Re: Response to Case Closure Denial and Directive for Work Plan Addendum
Former Chevron Service Station No. 94612
3616 San Leandro Avenue,
Oakland, CA
ACDEH Case No. RO233

Subject: Response to Case Closure Denial and Directive for Work Plan Addendum Submittal

Subject: Response to Request for Closure, Fuel Leak Case No. RO0000233 (Global ID # T0600100333), Chevron #9-4612, 3616 San Leandro Street, Oakland, 94601

Figure 1. Site Plan Showing Groundwater Concentrations – Second Quarter 2017
Attachment A. ACDEH Letter Dated October 6, 2017
Attachment B. Hydrographs

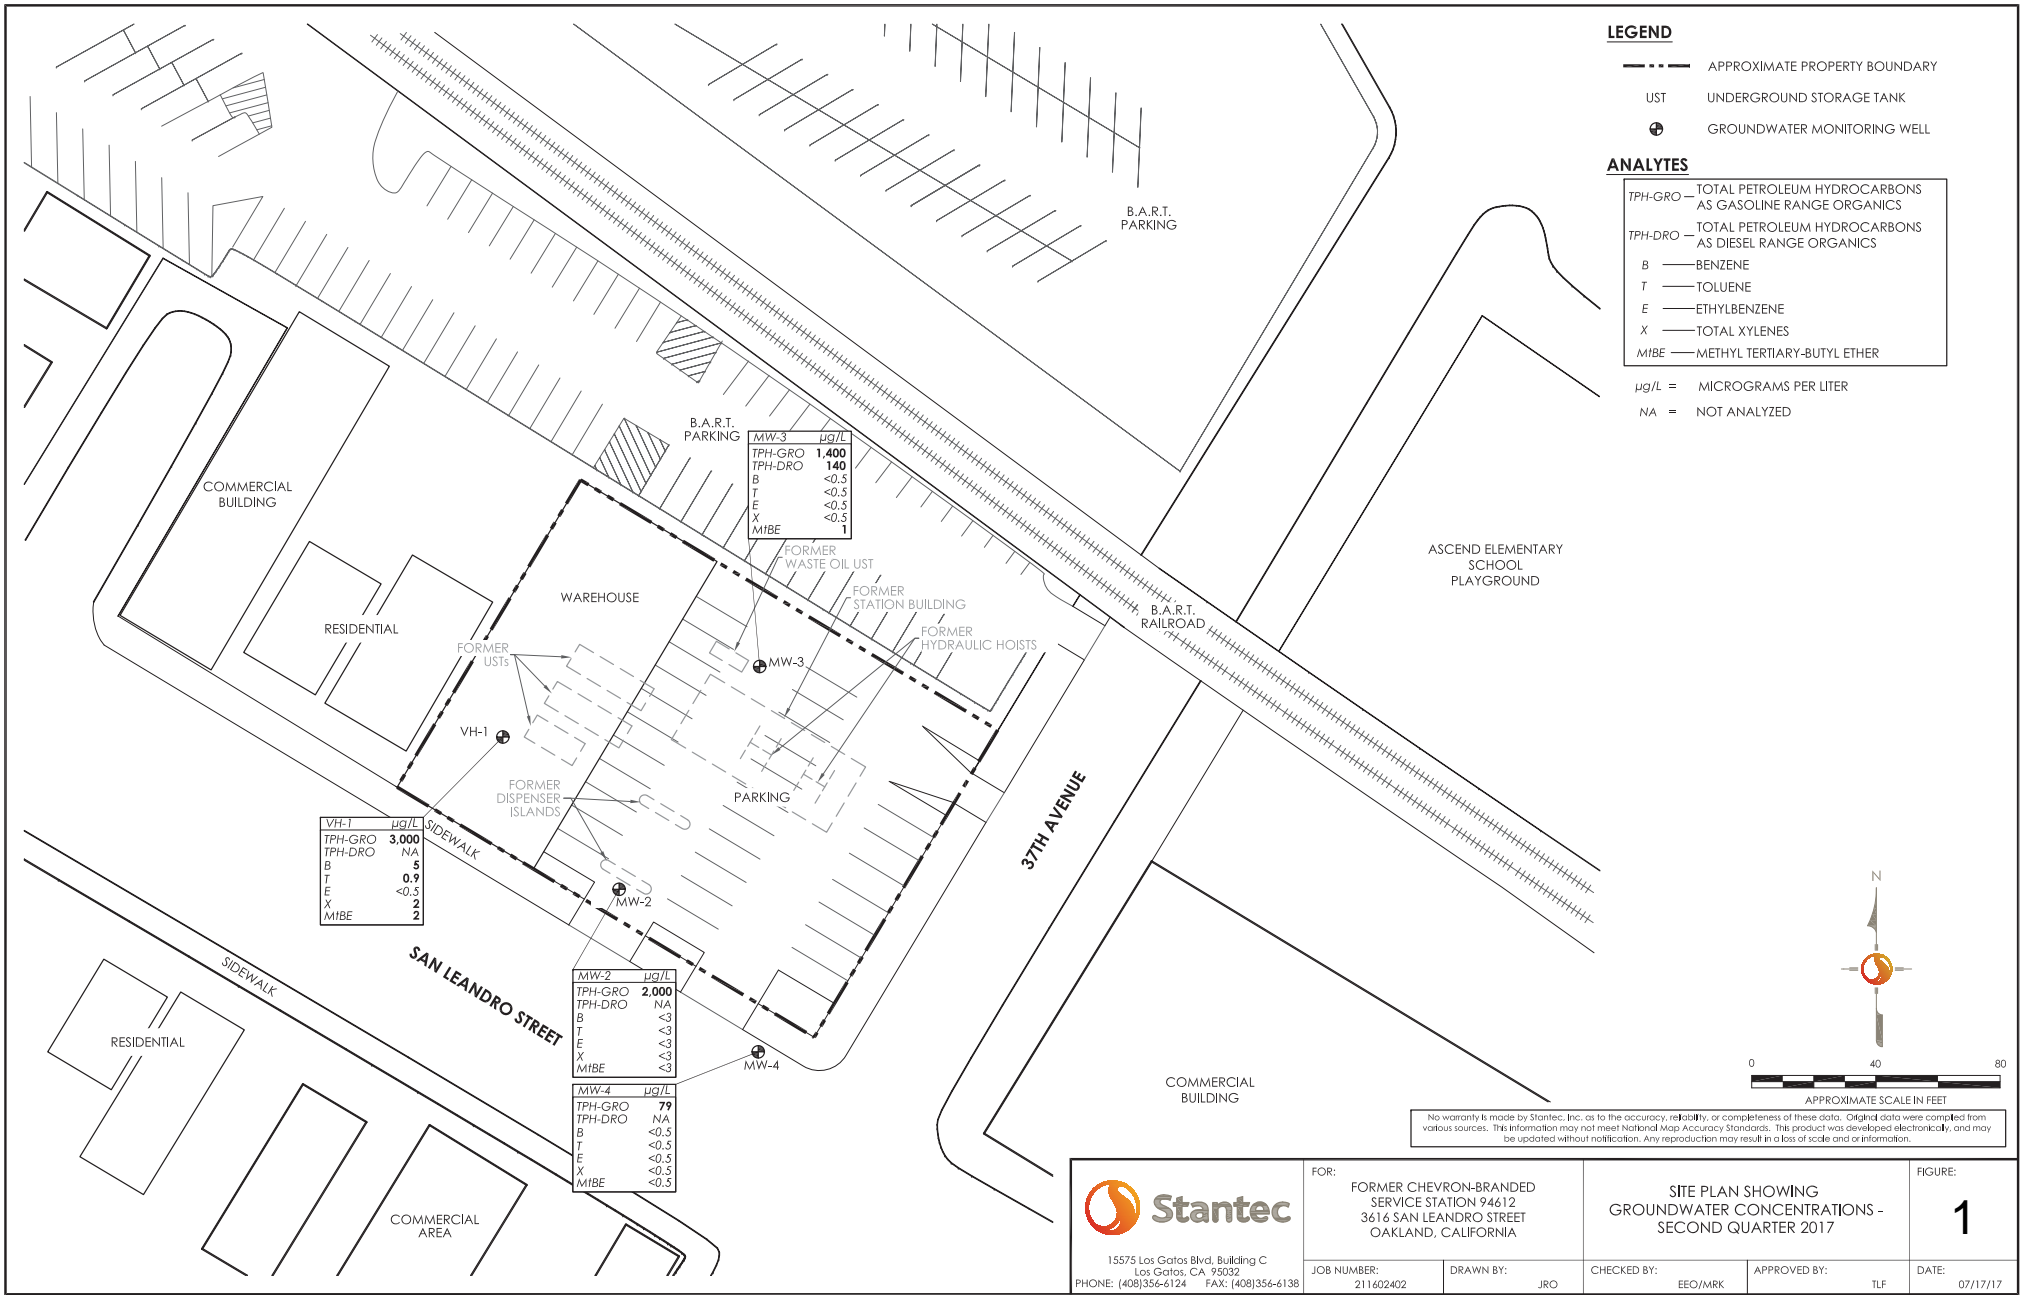
Section 2.3 of the *Technical Justification* document provides a table of the average, 90th percentile, and maximum plume lengths for benzene, methyl tertiary butyl ether (MTBE), and TPH-g. The average, 90th percentile, and maximum plume lengths identified for TPH-g are 248 feet, 413 feet, and 855 feet, respectively. A table note indicates that “TPH-g is shown for comparison purposes only. The [LTCP] does not set criteria for TPH.” Section 4.1 of the document further states that “a total separation distance from the source area to the receptor of about 500 feet should be protective for 90% of plumes from UST sites, and a total separation distance from the source area to the receptor of about 1,000 feet should be protective for virtually all plumes from UST sites.” CEMC contends that a plume length no greater than the average (248 feet), as referenced in the *Technical Justification* document, should be applied at the site, based on the low to non-detect concentrations of specific petroleum-hydrocarbon constituents (e.g., benzene, toluene, ethylbenzene, and xylenes [BTEX] and MTBE) (**Figure 1**).

2. and 3. In the October 6, 2017, letter, ACDEH generally agrees that the site meets the groundwater-specific criteria of the LTCP with regard to groundwater concentrations, except for “a consistent and clear increasing concentration trend in the downgradient direction onsite,” based on an increase in TPH-g concentrations “in the downgradient direction onsite from well MW-3 to MW-2 or VH-1.”

A rose diagram of the site groundwater flow direction shows a predominant trend toward the south-southwest. The former USTs were located in the western area of the site; thus, VH-1 and MW-2 are located generally down-gradient (to the south-southwest) of the former USTs and dispenser islands, and MW-3 is located generally up- to cross-gradient (east-northeast), of these former source areas. Although MW-3 is located in the vicinity of a former waste-oil UST, it is unlikely that a waste-oil UST would have contributed more significantly to TPH-g concentrations in groundwater than gasoline USTs or dispenser islands. It is reasonable to expect that TPH-g concentrations in groundwater would be higher at wells located in closer proximity to and/or down-gradient of the former gasoline UST/dispenser island source areas.

The former service station features were removed from the site in 1976, and groundwater monitoring began in 1988, nearly 30 years ago. The historical groundwater monitoring data clearly show stable TPH-g concentration trends in groundwater at each of the onsite wells. Benzene and MTBE concentrations clearly show a decreasing trend. In fact, dissolved-phase benzene concentrations never exceeded 1,000 micrograms per liter (µg/L), except for five instances at VH-1 from August 1988 to May 1993 (with a maximum of 3,300 µg/L), and two instances at MW-2 from August 1993 to August 1994 (with a maximum of 1,300 µg/L). During the June 2017 groundwater sampling event, benzene was detected in the groundwater sample collected from VH-1 at 5 µg/L, and not detected above the laboratory detection limit in the groundwater samples collected from MW-2 through MW-4. Dissolved-phase MTBE concentrations have never exceeded 590 µg/L. During the June 2017 groundwater sampling event, MTBE was detected in the groundwater samples collected from VH-1 and MW-3 at 2 µg/L and 1 µg/L, respectively, and was not detected above the laboratory detection limit in the groundwater samples collected from MW-2 and MW-4.

VH-1 TPH-GRO, Benzene, & MtBE Concentrations and Groundwater Elevations vs. Time
 Former Chevron-branded Service Station 94612
 3616 San Leandro Street
 Oakland, California

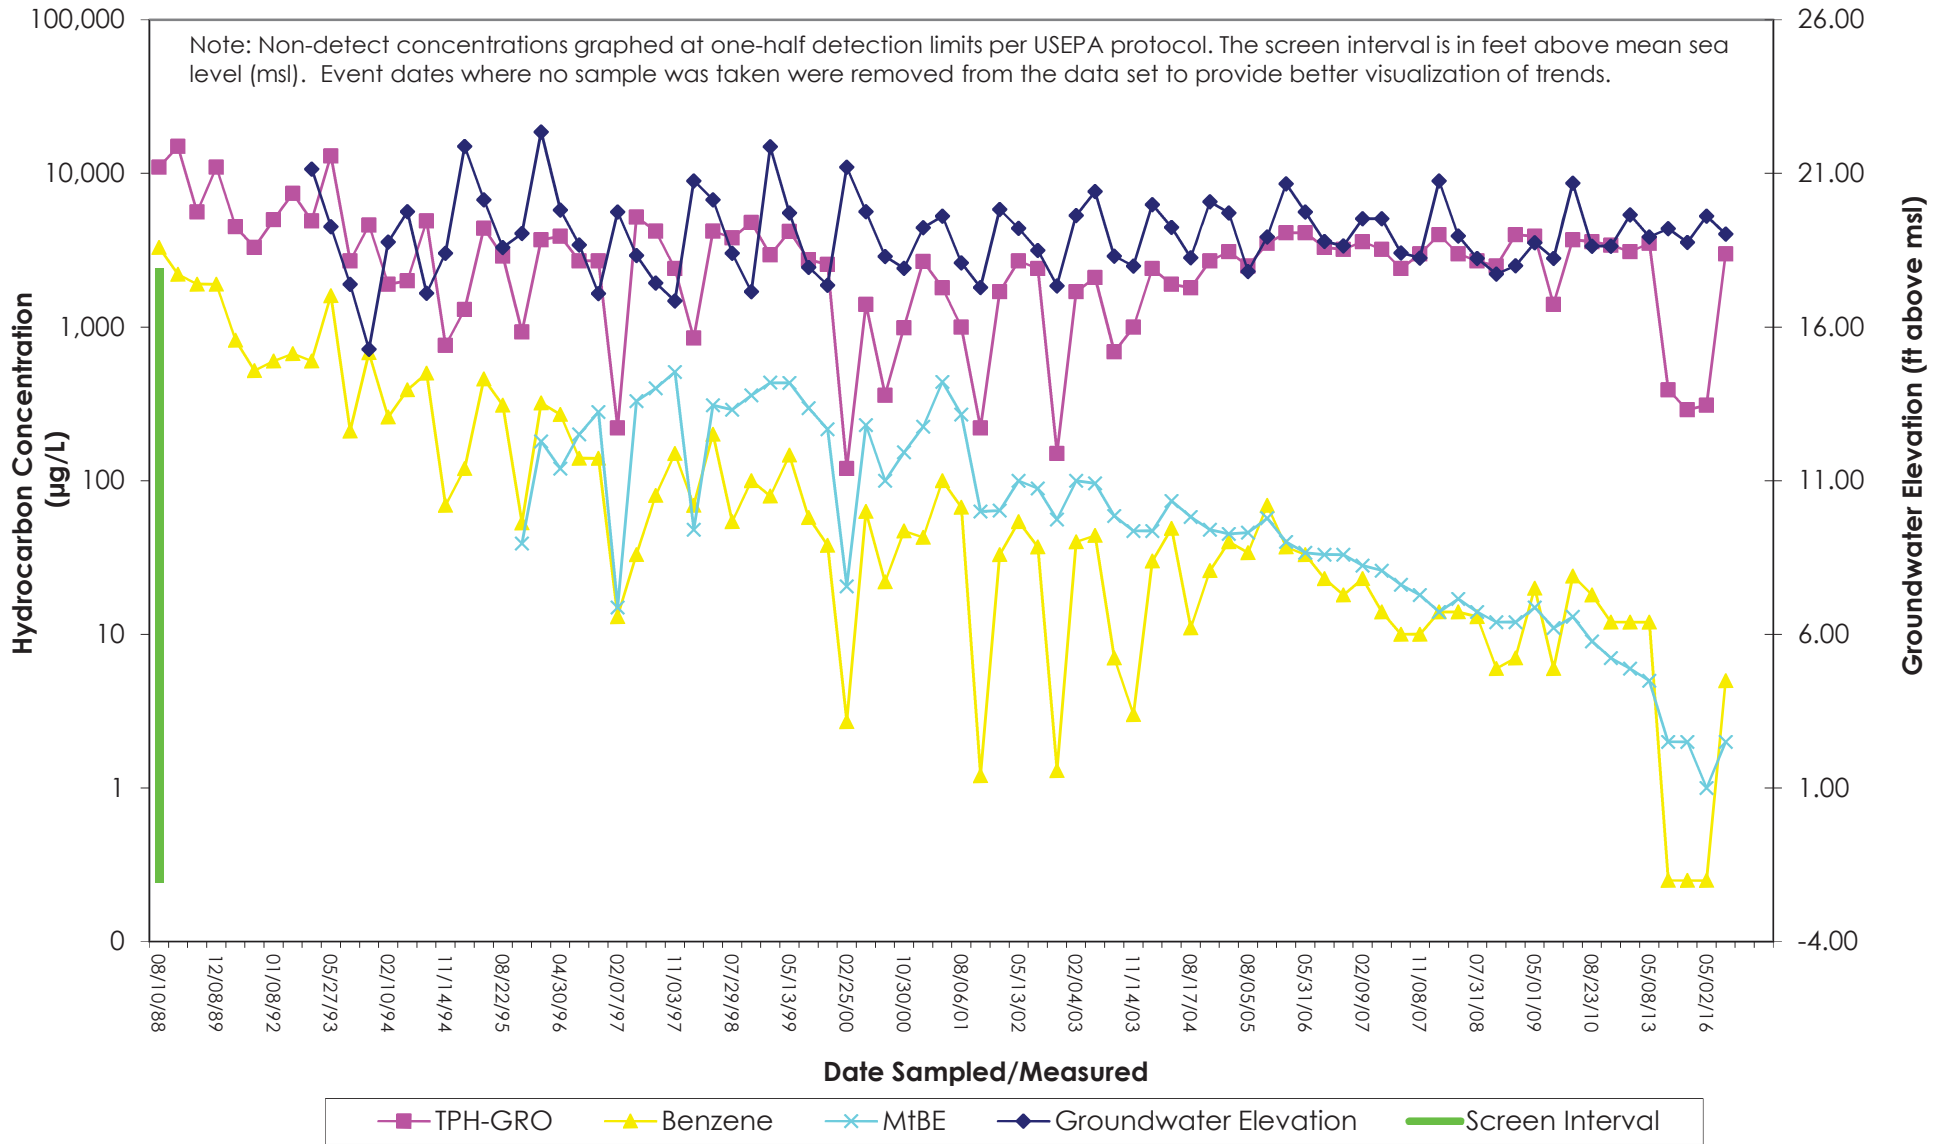
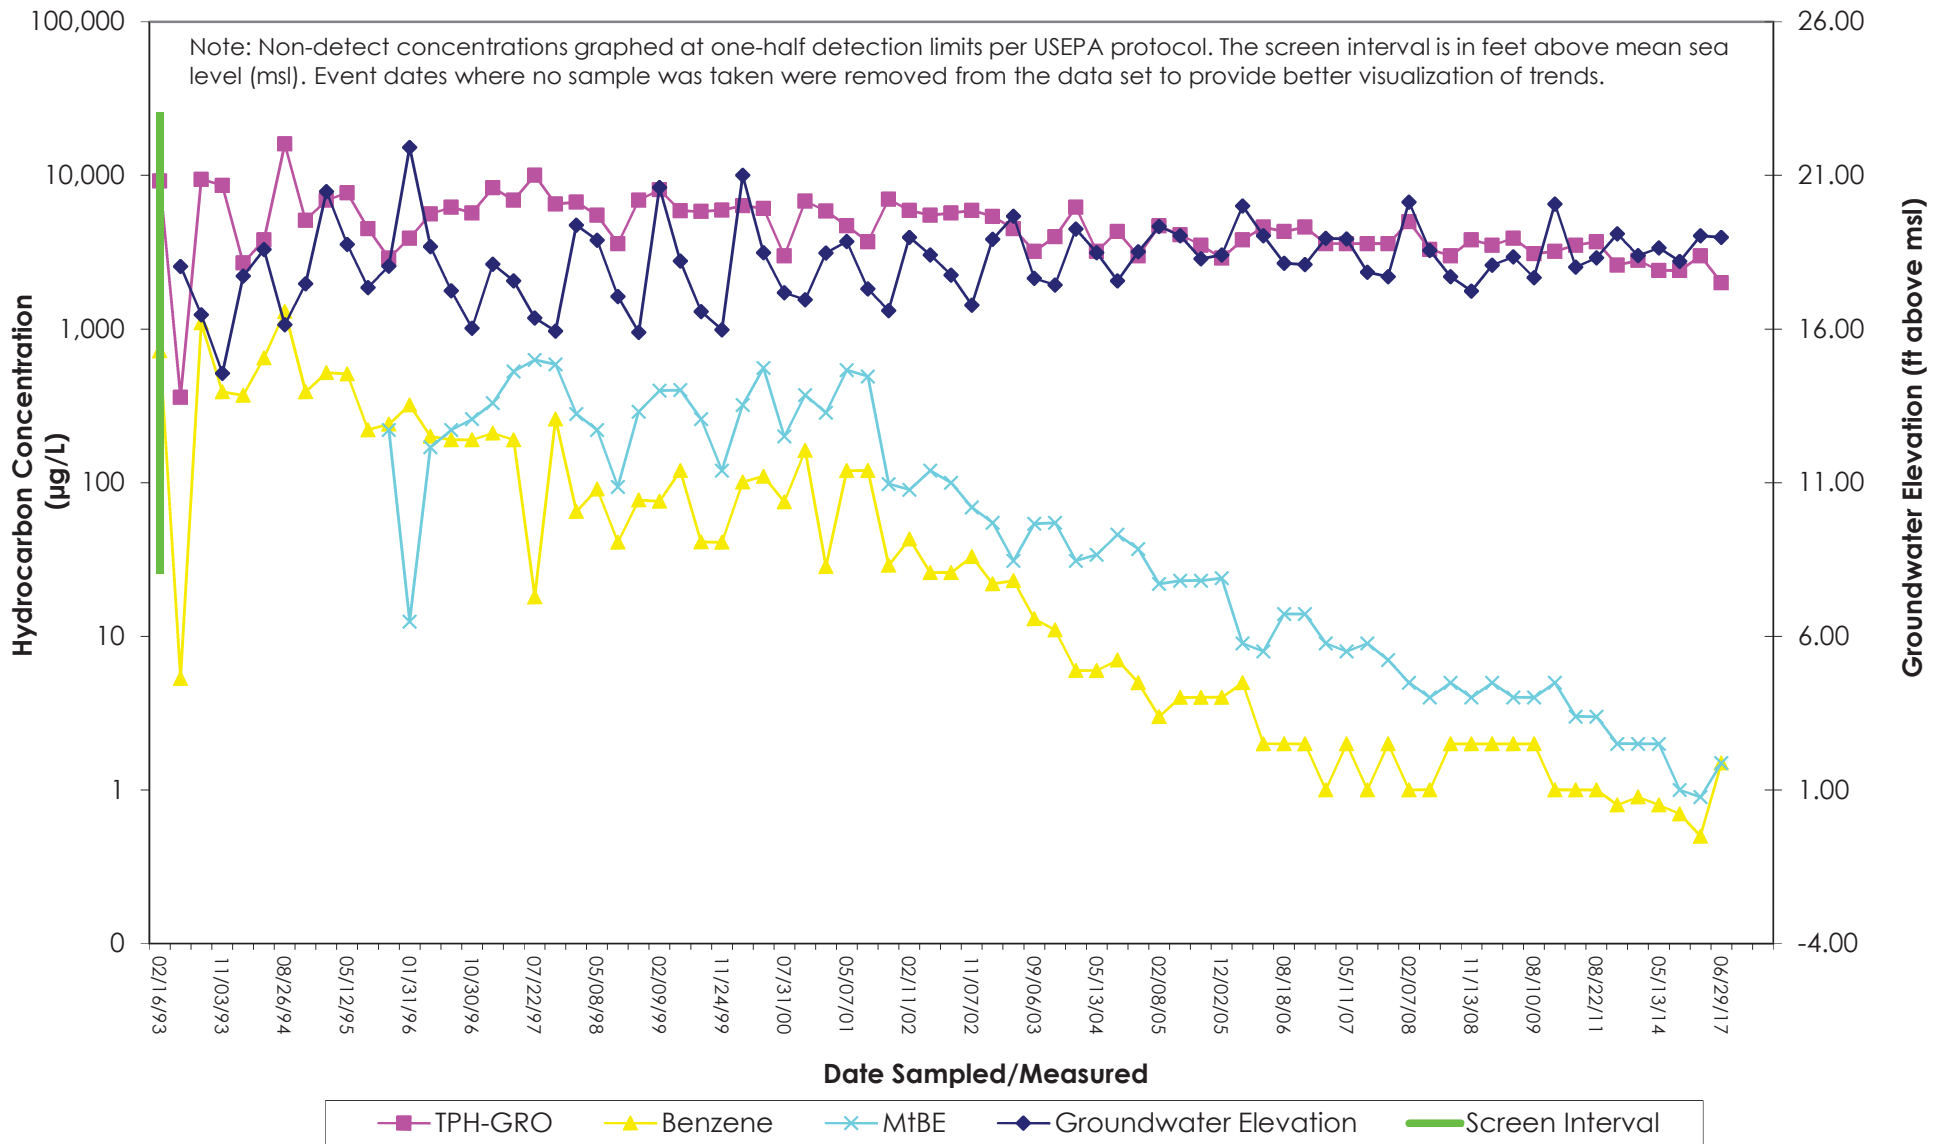
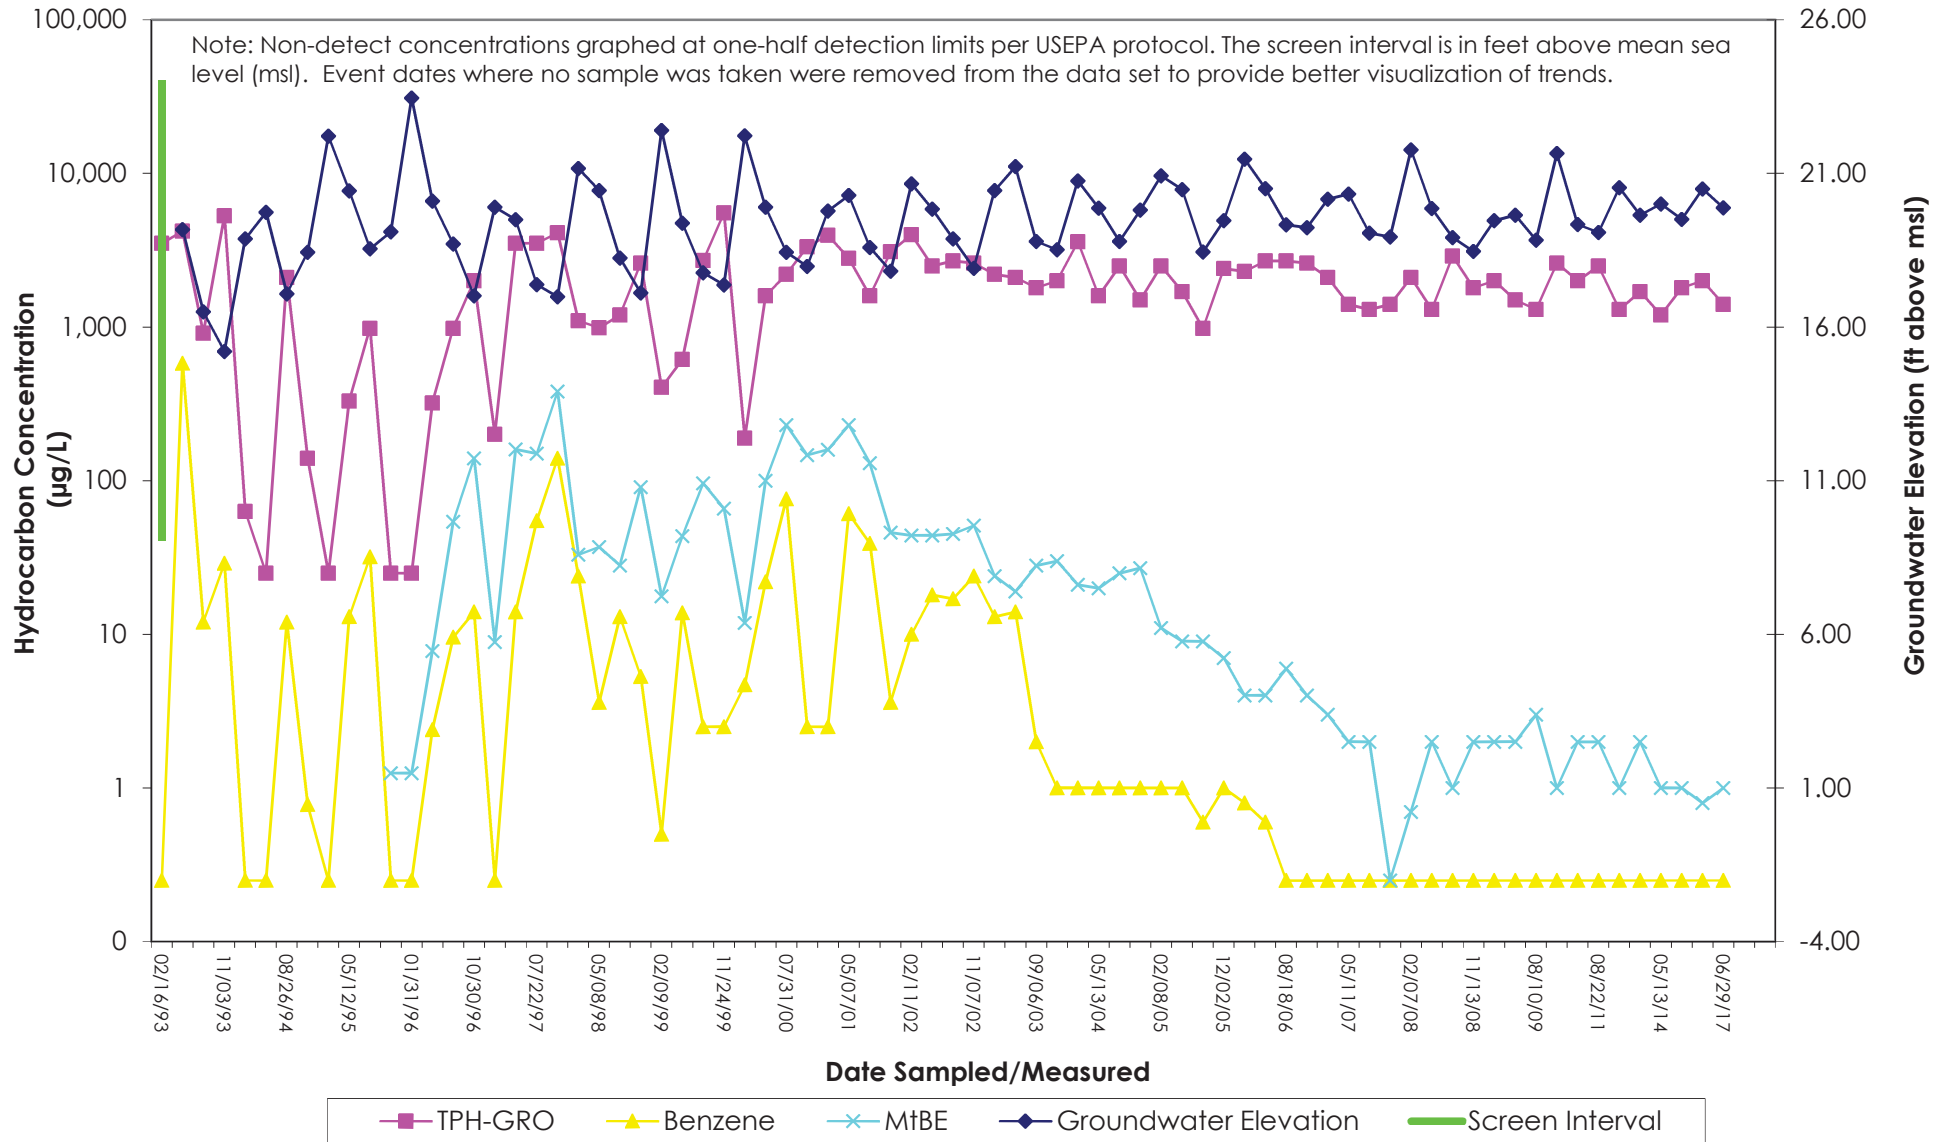
- b. **Groundwater Concentrations** – ACDEH is in agreement that, in general, groundwater concentrations are stable and meet this portion of the Criteria. However, with one exception, review of onsite groundwater concentrations for Total Petroleum Hydrocarbons as gasoline (TPHg) indicates a consistent and clear increasing concentration trend in the downgradient direction onsite over a not insubstantial period of time (a minimum of 10 years, back to at least February 2007). The most recent data from the referenced groundwater monitoring report is consistent with this observation, and TPHg concentrations increase in the downgradient direction onsite from well MW-3 to MW-2 or VH-1. These recent concentrations ranged from 1,400 micrograms per liter ($\mu\text{g/l}$), to 2,000 $\mu\text{g/l}$, to 3,000 $\mu\text{g/l}$, respectively. As noted above, the single exception is for the period between May 2014 and May 2016 at VH-1. TPHg concentrations in well VH-1 decreased during this period from those in upgradient well MW-3; however, concentrations in well MW-2 were consistently higher than those in well MW-3 during this brief period. Thus, consistent with multiple previously sampling events, the downgradient wells do not currently define the downgradient extent of groundwater TPHg contamination (please see Technical Comment 1c below as well).

that exceeds WQOs at the site, it appears that ACDEH is using it as the benchmark for plume delineation. Additionally, hydrographs presented in the second quarter 2017 semiannual groundwater monitoring report indicate historical dissolved-phase TPH-g concentrations with stable to decreasing trends (**Attachment B**).
